Service Bulletin

S.B. No: 187

Title: INSPECTION FOR CLEARANCE BETWEEN RUDDER PEDAL AND MIXTURE/PROP. SPEED BRACKET. ALSO INCLUDES GENERAL RUDDER PEDAL CLEARANCES.

Applicability: T67M200 (Works No. 2264 & 2265 only), T67M260 and T67M260-T3A.

FIGURE 1
SHOWING CLEARANCE MIXTURE/PROP SPEED BRACKET TO No. 3 PEDAL

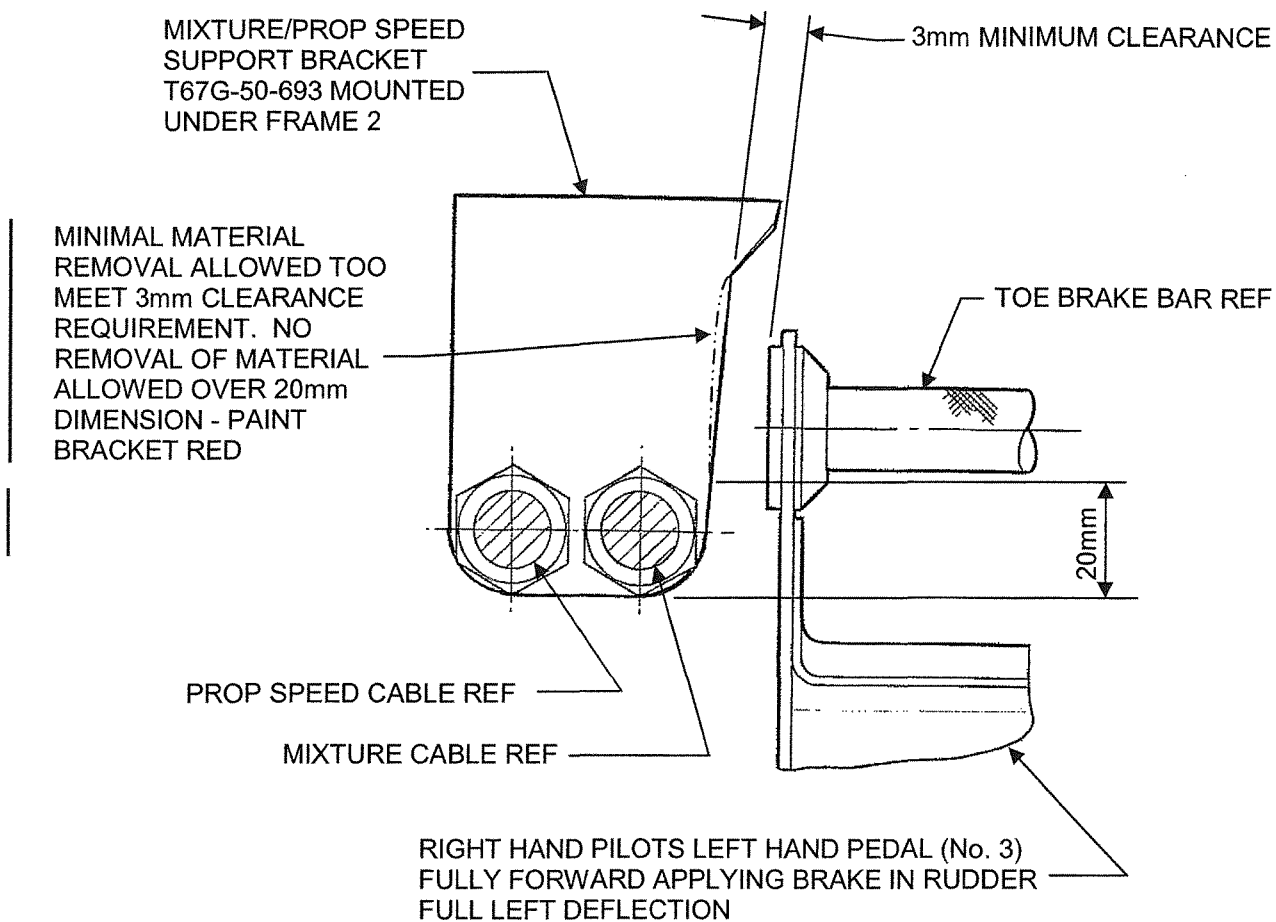
1. With Right Hand pilots left pedal (Pedal No. 3) adjusted fully forward, with left rudder applied, apply brake together with a left hand side force on the pedal. Check for clearance on mixture/propeller speed cable support bracket. Refer Figure 1.

2. Clearance should be a minimum of 3mm. Figure 1 refers.
 - 2.1 If the clearance is less than 3mm, the following inspection and corrective actions, paragraphs 3 to 25, shall be carried out in order to increase the clearance up to the required minimum of 3mm.

16. Ensure correct clearance of No 3 pedal to Mixture/Prop. Speed bracket; refer Paragraph 2 above, has still been maintained. If clearance has still not been achieved then it is allowable to remove some of the bracket material to obtain the clearance, paint modified bracket red and annotate in log book, this is a non-preferred solution. Please inform SACL of the amount of material to be removed prior to removal. If this interim solution still does not achieve the required clearance then inform SACL. On applicable aircraft with interim solution applied, at next annual from the date of receipt of this Service Bulletin invoke Mod M1030 "Introduction of Revised Propeller Speed/Mixture Bracket and Mounting to Ensure Rudder Pedal Clearance".

FIGURE 2

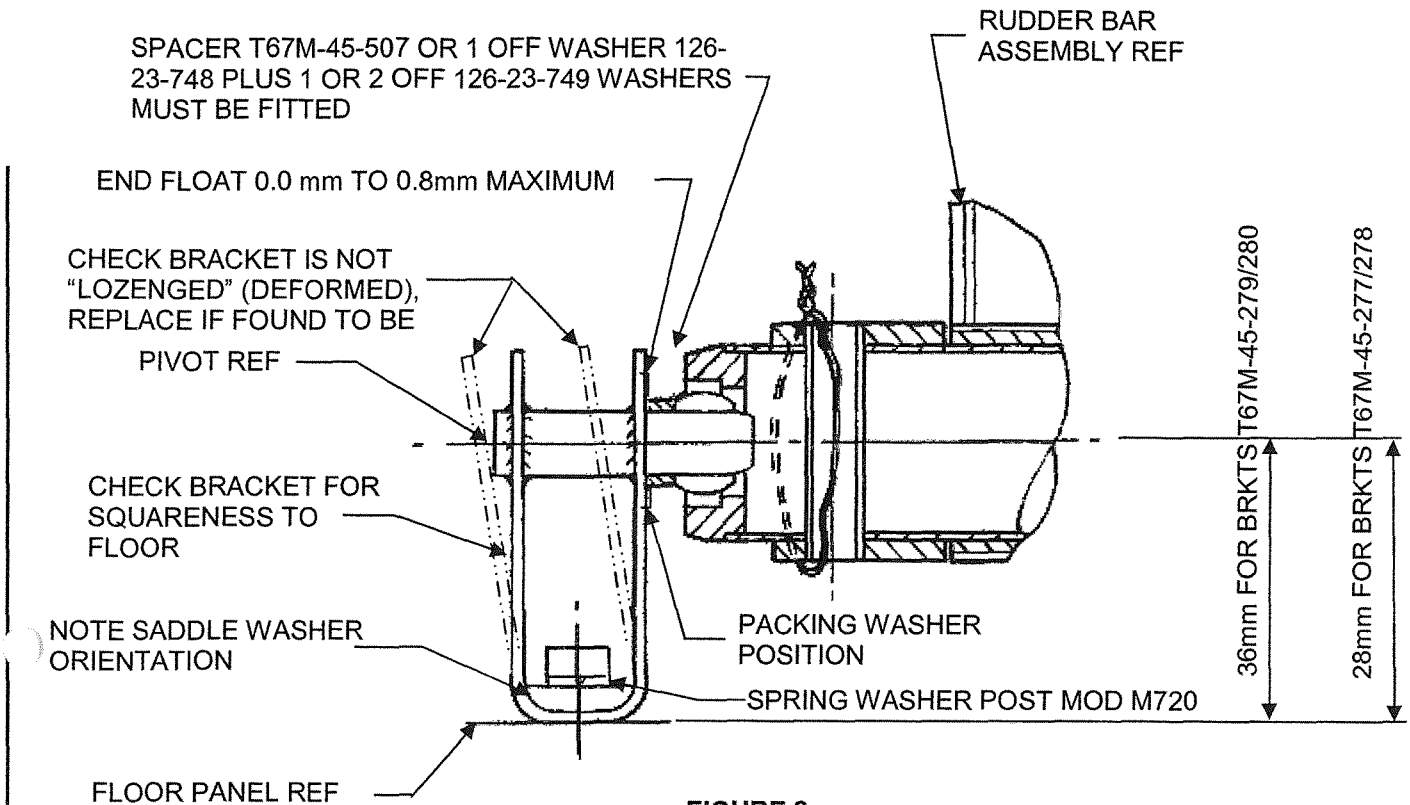
4. Check rudder pedal bar end float is no greater than 0.8mm. Acceptable end float is 0.0mm to 0.8mm. If end float is greater than 0.8mm then rectify IAW paragraph 9. Refer Figure 2.

5. Check that the Rudder Pedal bar port outboard support bracket, ref. Figure 2 and 4, is square to floor and not "lozenged" and there is no deformation to its base. Check floor panel under area of bracket, inspect for cracking which could allow the bracket to lean. If necessary remove floor panel and check for signs of cracking in the floor around the anchor nuts on Pre Mod M919 aircraft or the anchor nut mounting plate Post Mod M919 aircraft, refer Figure 3. Any GRP damage will be shown as a white shadow on the GRP, with cracking felt as a rough edge. A light shining up through the floor will show a shadow.

7. Should Rudder bar support bracket be damaged, replace with a new item. Ensure brackets are secured with a torque of 58lbf in (6.5Nm). Ensure spring washers are fitted; Mod M720 "Introduction of Spring Washers to Rudder Pedal Lay-shaft Mounting Bracket Screws" refers. Ensure when refitting brackets that the saddle washer, T67M-45-537, is re-fitted and is assembled with its corner radius into the brackets radius, refer Figure 2. Ensure that the taller mounting brackets, T67M-45-277/278, are supporting Rudder Pedal Bar T67M-45-257, i.e. Port Rudder Bar, refer Figures 2 and 4.

8. Check the remaining rudder bar support brackets, are square to floor and are not "lozenged" and there is no deformation to their bases, reference Figures 2 and 4. If any bracket is found to be suspect replace with new item. Check floor under any damaged support bracket by removing panel. Ensure washers and brackets are correctly assembled refer paragraph 7 above. Inform SACL of any damaged bracket or additional floor damage. Assemble item as per paragraph 7 and ensure end float is as stated in paragraph 9. Ensure bonding leads are correctly fitted, carry out bonding check refer relevant aircraft's Maintenance Manual.

9. Referring to Figure 2 ensure at each rudder bar pivot position that there is one spacer T67M-45-507 OR one off washer 126-23-748 and up to a maximum of two off washers 126-23-749, i.e. 3 washers maximum.

If end float greater than 0.8mm, then 1 off packing washer may be added at each pivot position as required, i.e. 126-23-105 washer or 126-23-748 washer or 126-23-749 washer.

If packing washers are required on the right hand rudder bar (T67M-45-259), then the packing washer, (or the thicker washer if a thick and thin washer are required) should be placed at the outboard pivot. When end float of 0.8mm maximum is achieved, ensure that the brake cylinders are not subject to undue side load. If in doubt, contact SACL.

FIGURE 4

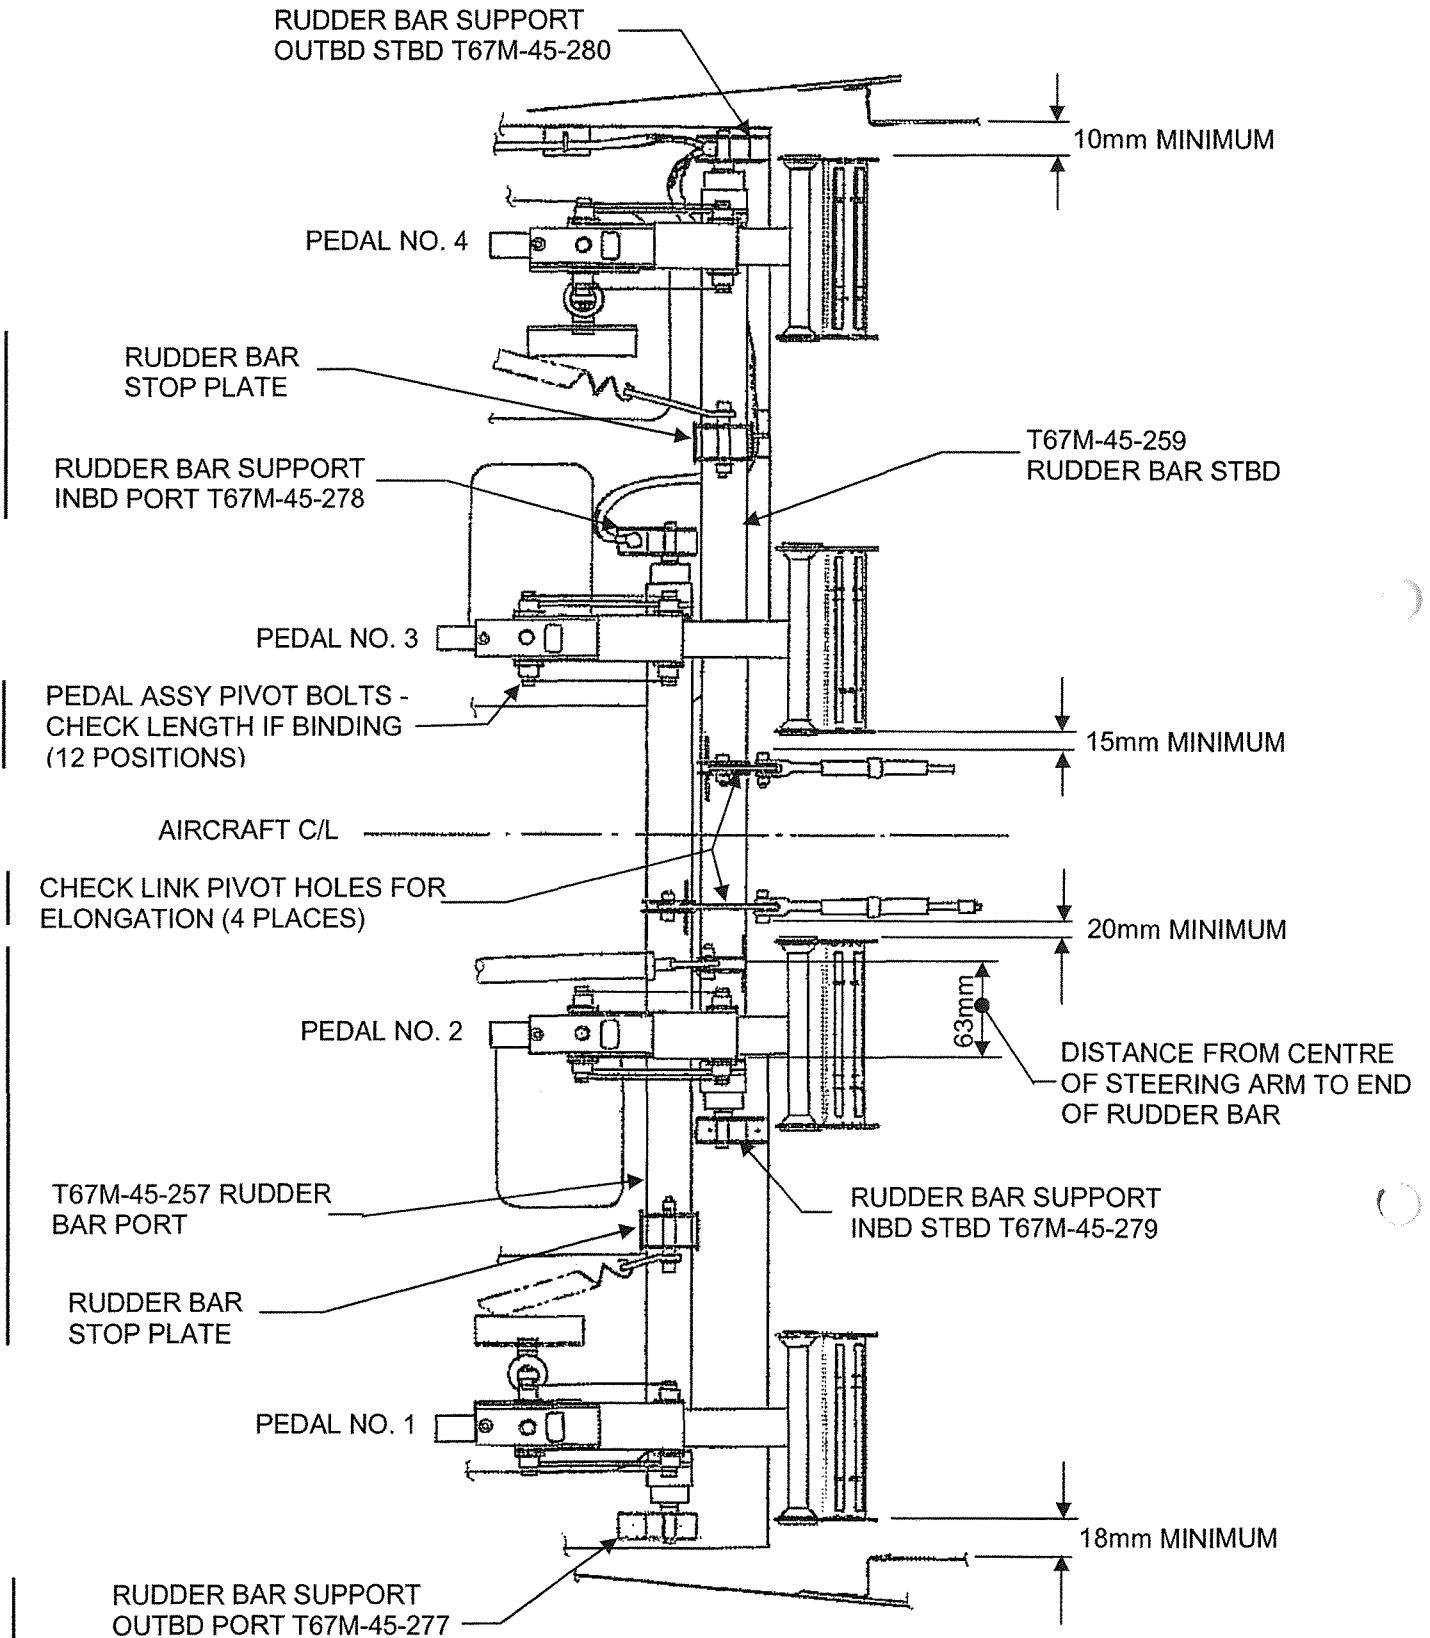
Note 2: Note rudder stop plates, positions indicated on Figure 4, are permitted with deformation assuming full rudder movement and clearances have been achieved and there is no cracking in the welds supporting the stop plates, if in doubt return rudder bar to SACL for rework.

14. Upon completion of rudder movement set-up ref. Paragraph 12 above, ensure minimum clearances of trim panel to pedal side plates and rudder cable to pedal side plates are met Refer Figure 4. Refer paragraph 9 for packing washers.

FIGURE 5

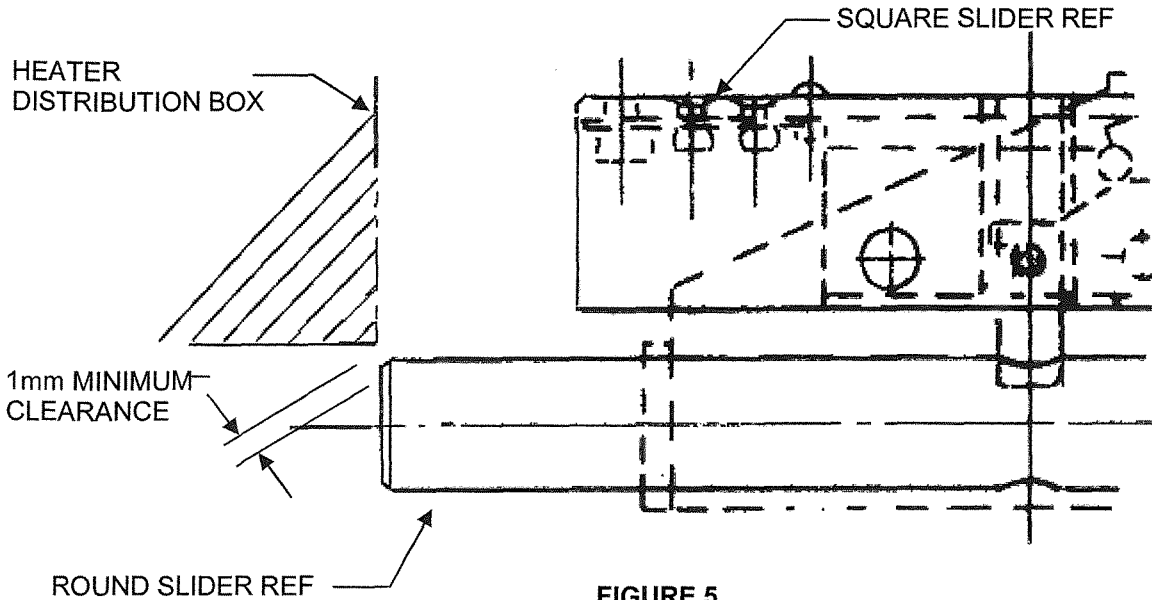
15. Ensure clearance of the no. 2 pedal slider to heater box clearance, is greater than 1mm, Figure 5 refers. Inform SACL if clearance is not achievable.

FIGURE 6

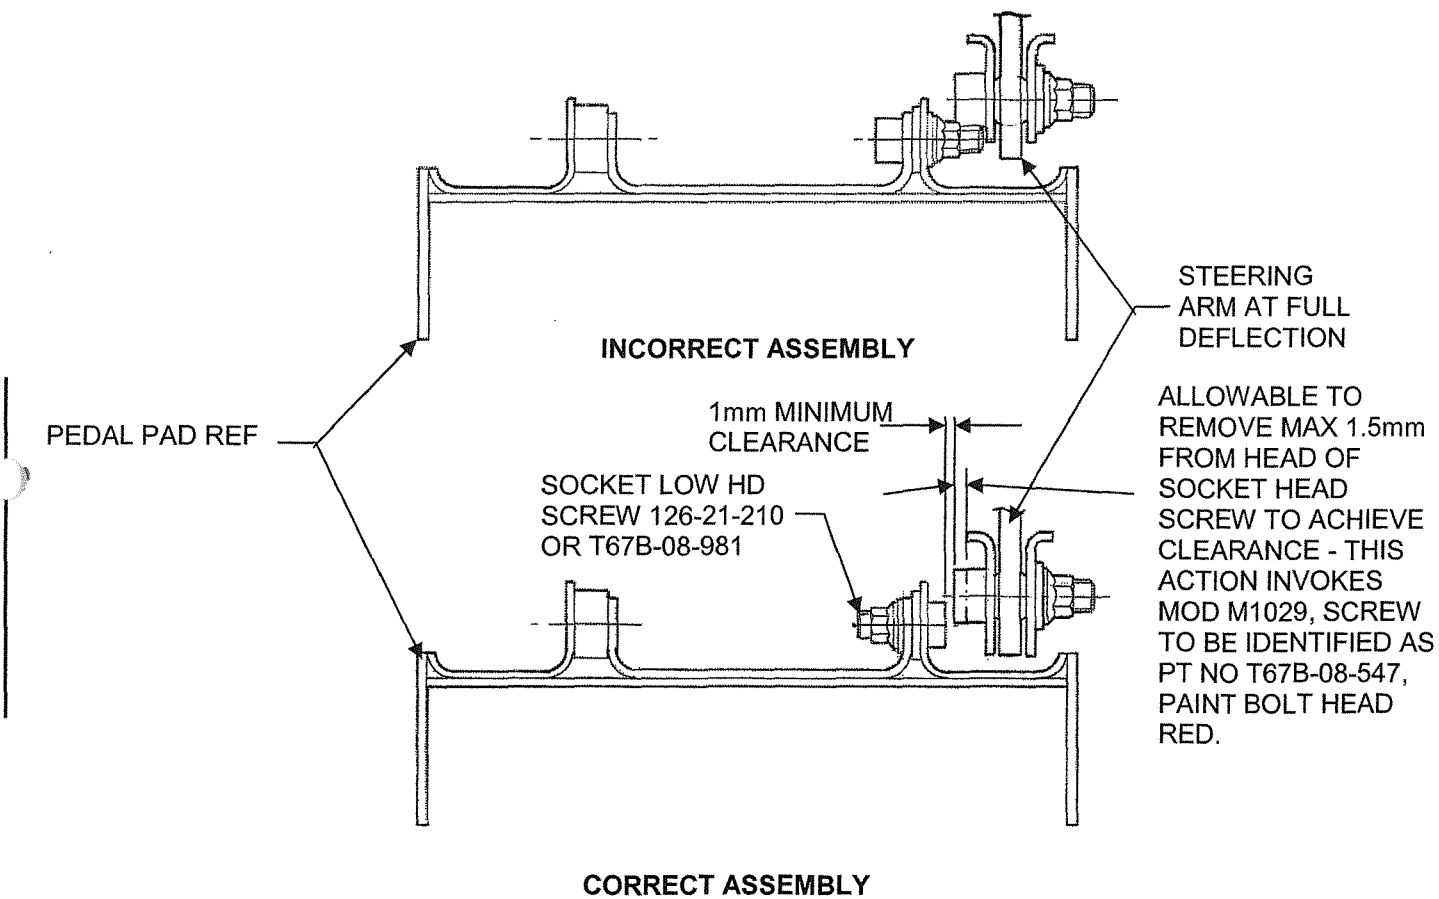
18. Ensure head orientation of rudder cable link low pan head bolt T67M-45-570 is outboard. T67M260 Maintenance Manual Figure 5-7 refers.
19. Ensure Pedal no 2 Pedal pad pivot bolt head height is less than 5mm and orientated, as shown in Figure 6. A minimum of 1mm clearance is required, if not, fit part no 126-21-210 or T67B-08-981, this invokes Mod M671 "Introduction of Low Head Rudder Pedal Pad Pivot Bolts – Pedal No. 2". If clearance is not still achieved check distance of steering arm from bar end, Figure 4 specifies. If the distance is incorrect, then return rudder bar to SACL for re-worked/new item. Alternatively if clearance of 1mm is still not achievable remove up to a maximum of 1.5mm from the steering arm screw this invokes Modification action M1029, Figure 6 refers, and paint modified screw head red.

FIGURE 7

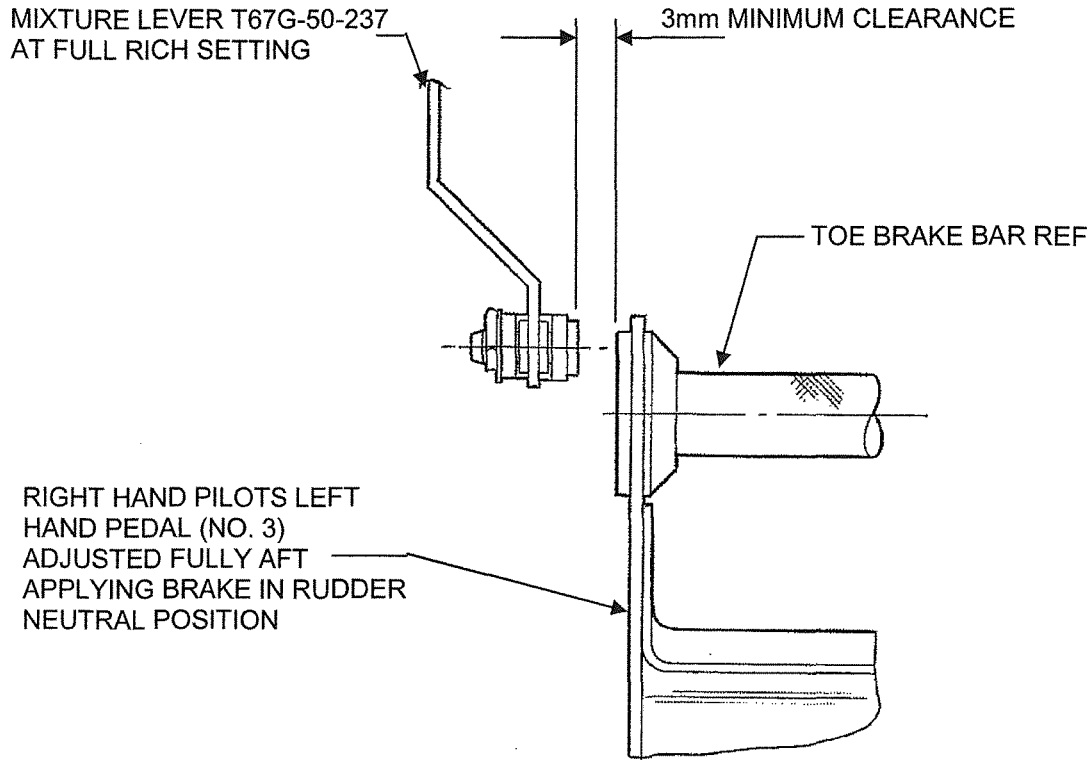
21. Ensure, that a minimum clearance of 3mm is achieved between Pedal No 3 and Mixture Lever operating arm, refer Figure 7. Refer paragraph 9 for packing washers.

FIGURE 8

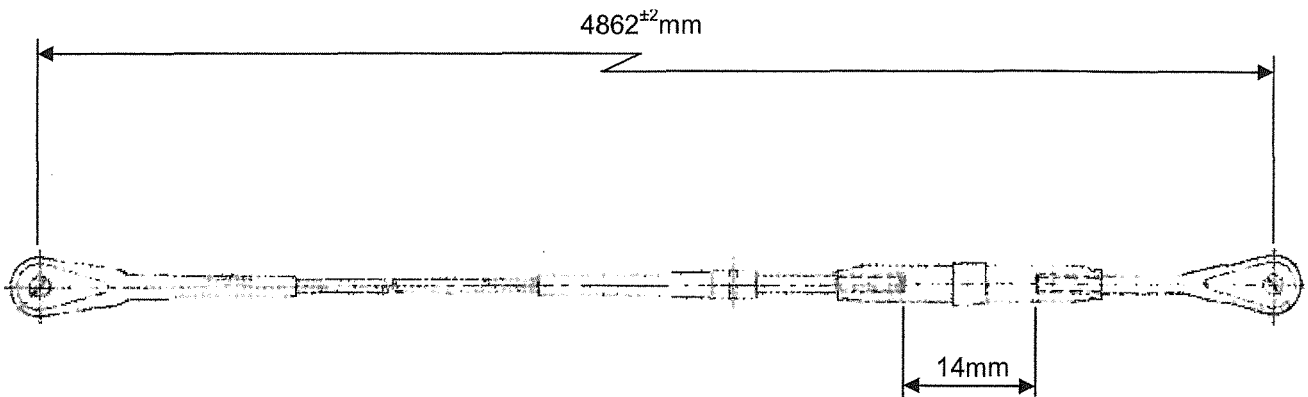
17. This paragraph is not applicable to aircraft with Post Mod M945 "Introduction of ISA +35°C Fuel System Improvements" incorporated. Ensure fuel pipe to rudder pedal slider clearance is met; refer T67M260 Maintenance Manual Paragraph, 5.6.5.1, the minimum acceptable clearance is now to be 5mm. If clearance cannot be achieved then; i) remove Rudder Cable and check length, length should be 4862 ± 2 mm, Figure 8 refers; ii) additionally check condition of rudder pedal assembly, refer paragraph 3.
